Metropolitan Development Commission Regional Center Hearing Examiner (May 23, 2024) Meeting Agenda

STAFF REPORT

Case Number	2024-REG-024
Address (approx.)	815 South Meridian Street and 25 East McCarty Street
Location	Center Township, Council District #18
Petitioner	Brian Shapiro, by David Rausch, AIA LEED AP
Zoning	CBD-2 (RC)
Request	Regional Center Approval to provide for updated plans for a proposed seven-story hotel and apartment development (previously approved for a six-story hotel through 2019-REG-107 and 2021-REG-063 and approved for a seven-story hotel through 2022-REG-024), with amenities, including a restaurant, courtyard, and roof-top lounge.

NORTH ELEVATION
Scale: 1/8" = 1'-0"

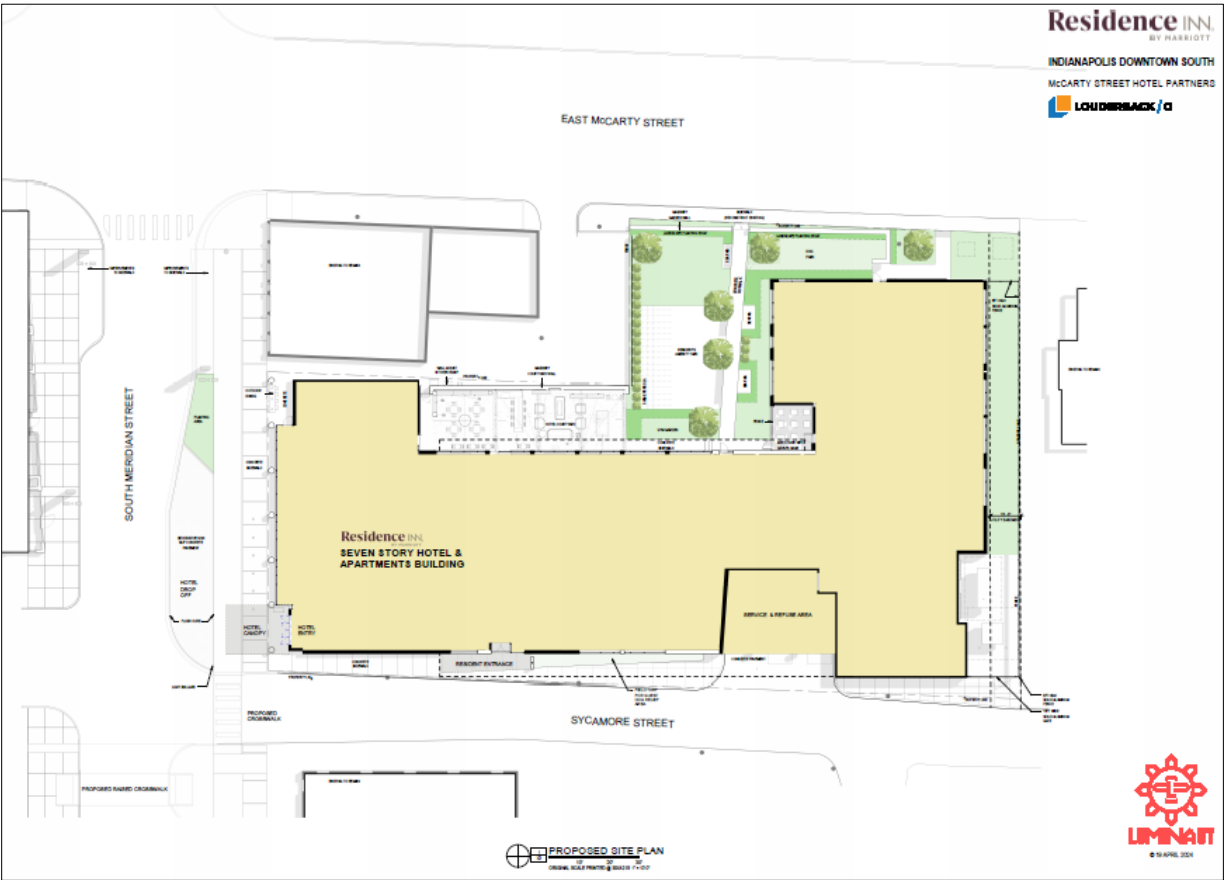
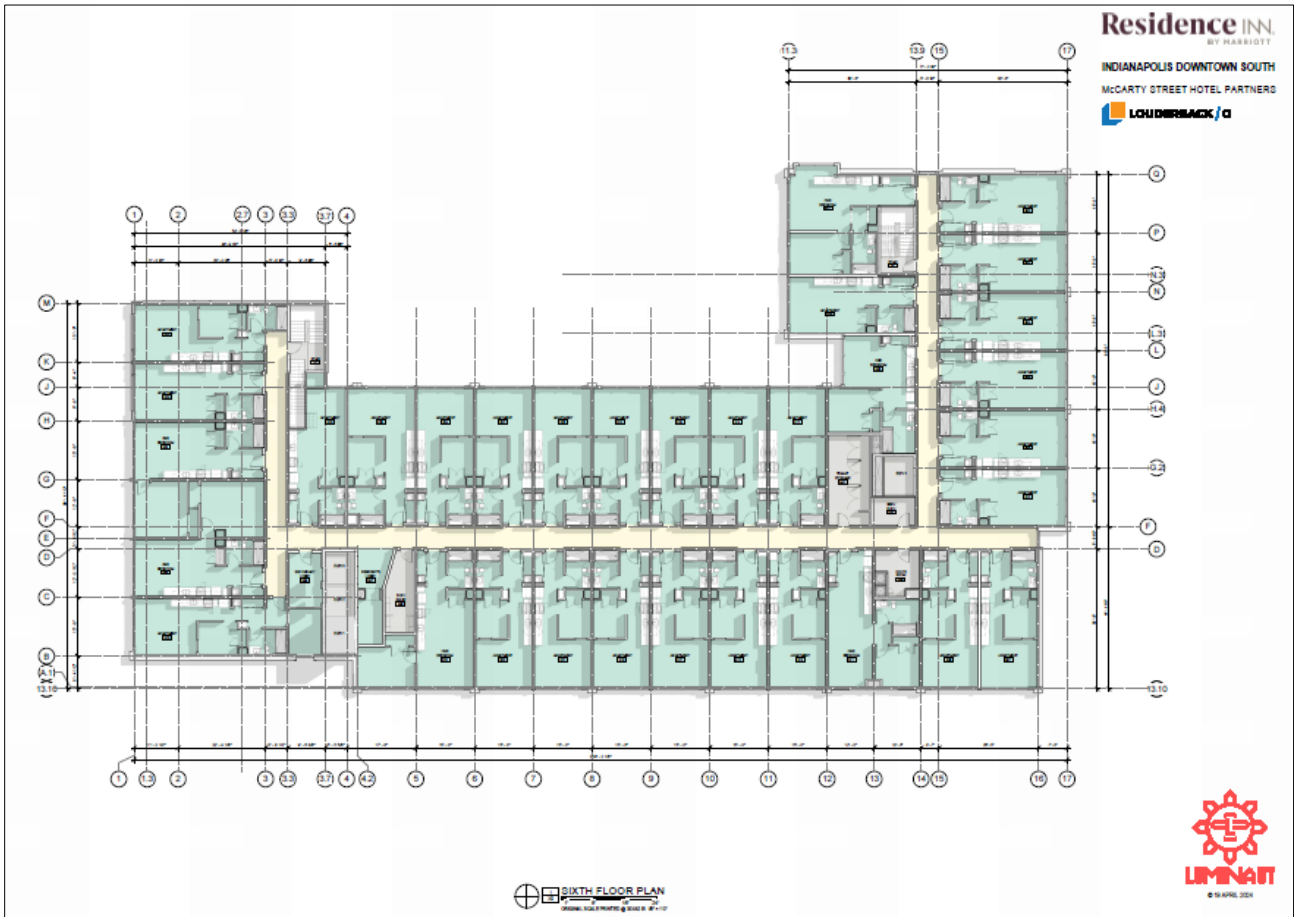
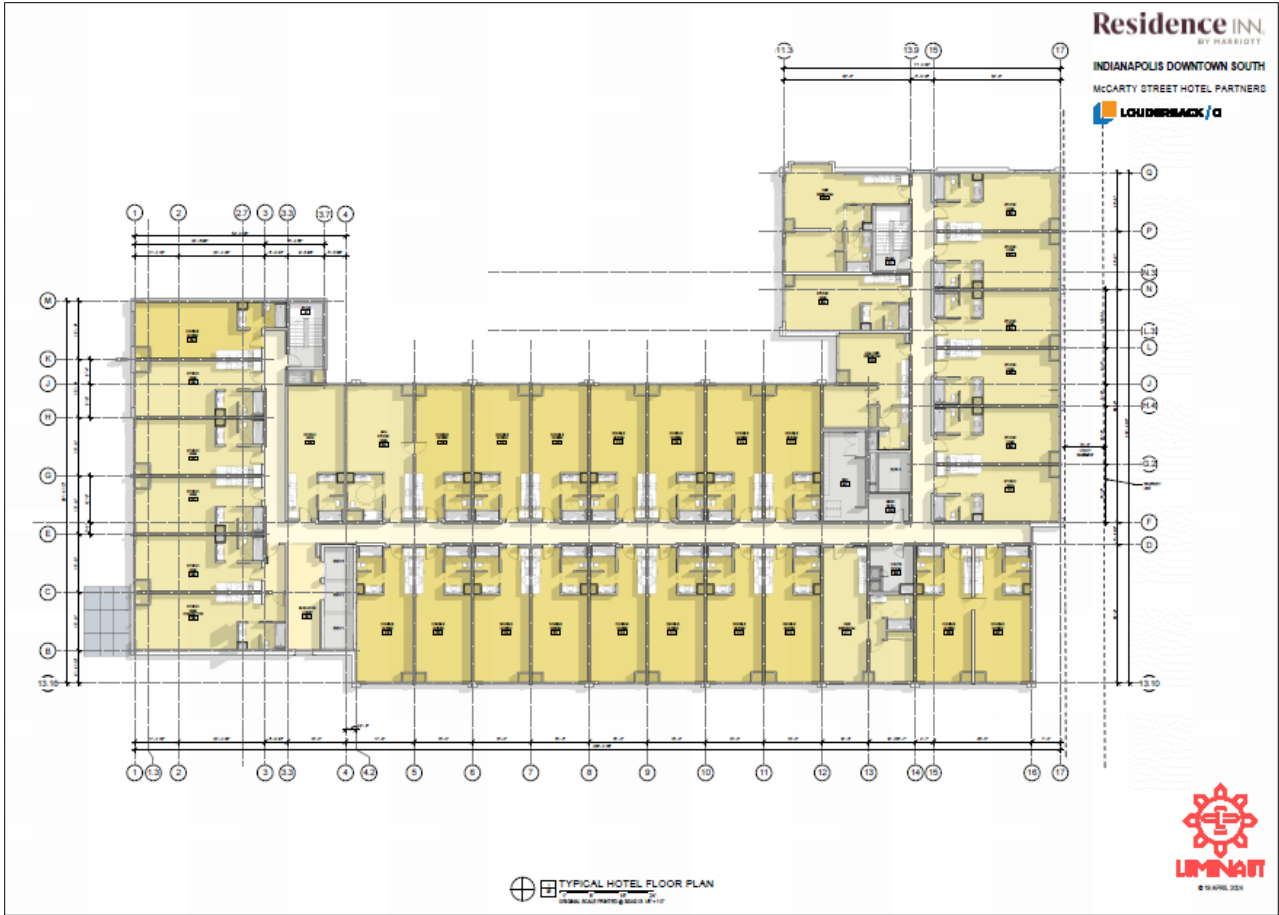
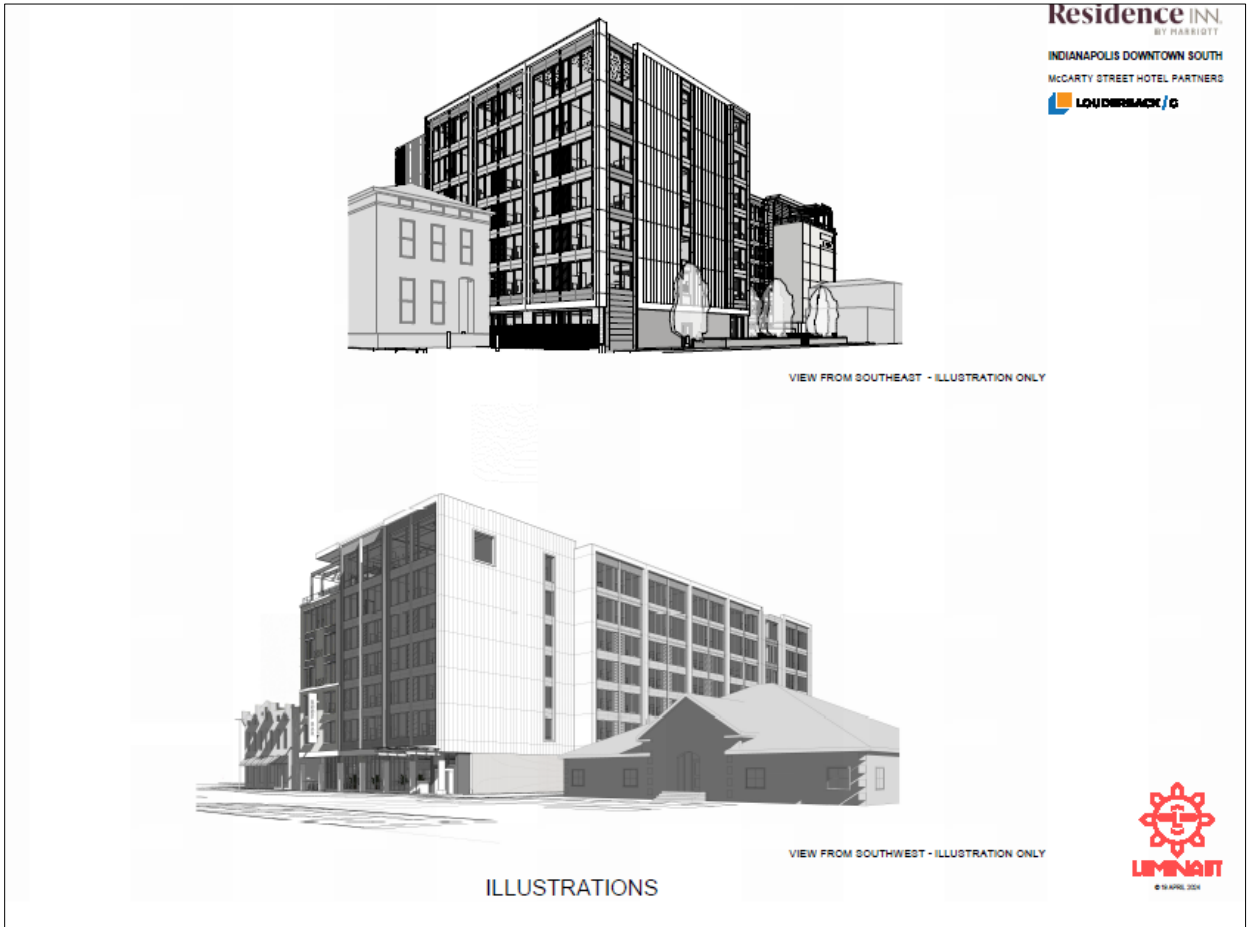
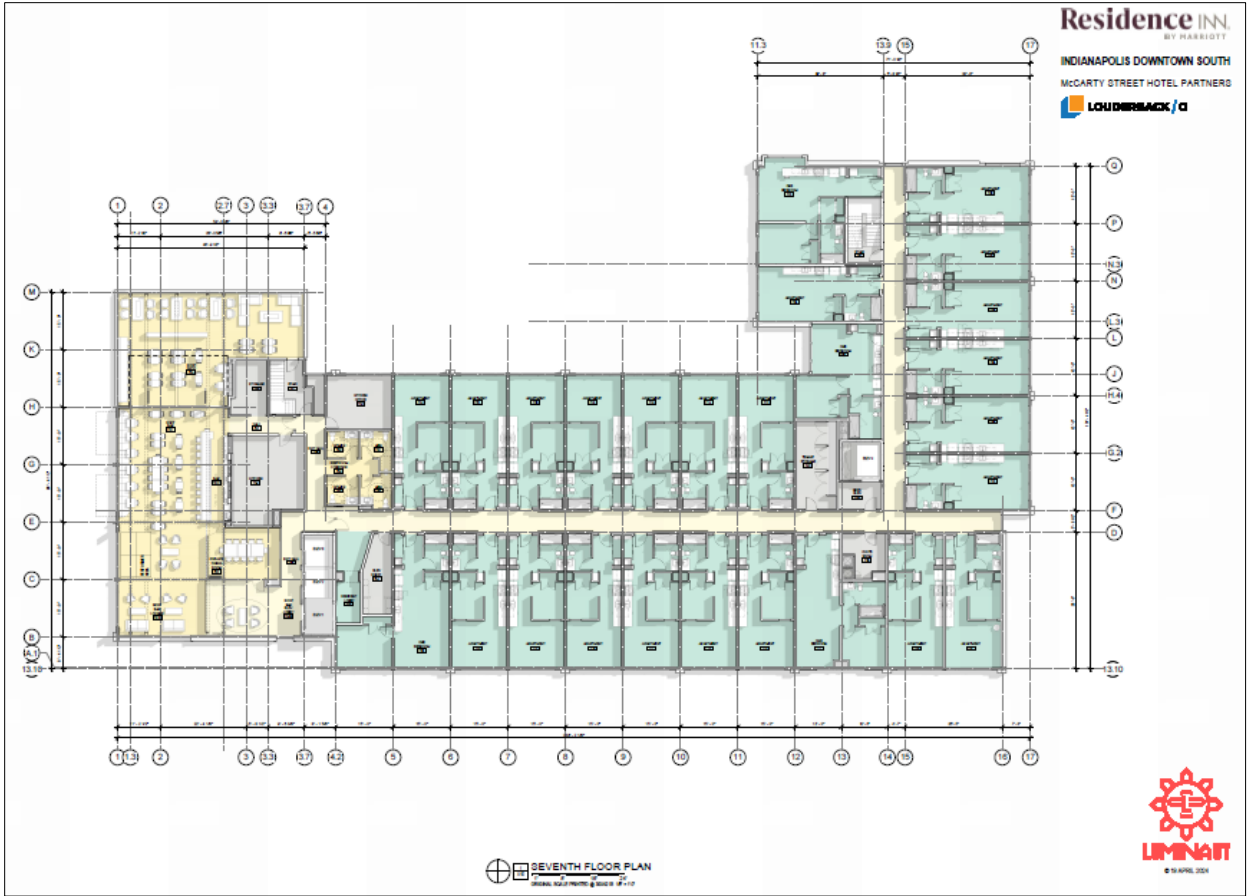
The most significant change would be the eastern portion of the north elevation, where the building would have fewer windows and a more 'solid' appearance. A new, vertical section of windows would project from the façade approximately 18" to 20", which reduces the solid effect. This revised elevation, while providing for fewer windows, would not negatively affect the overall high-quality design of the structure. Another proposed change would be more windows on the northern-most west elevation (Partial West Elevation, below). The previously approved plans provide for a much more solid appearance. This would be an improvement over the approved plans. Finally, a notable change was made by removing balconies from the upper levels of portions of the structure. While this eliminates outdoor space for those units, it would not negatively affect the overall high-quality design of the structure.

Review of the Guidelines against the submitted plans reveals a few items that remain outstanding or require explanation.

1. Guidelines CA 2.1.4 and CA 2.4.1 require minimum standards for visible light into the building. The submitted plans do not specify the window detail, such as light transmissivity. Detailed window information for the windows adjacent to grade level shall be submitted for planning staff review and approval prior to the issuance of an Improvement Location Permit.
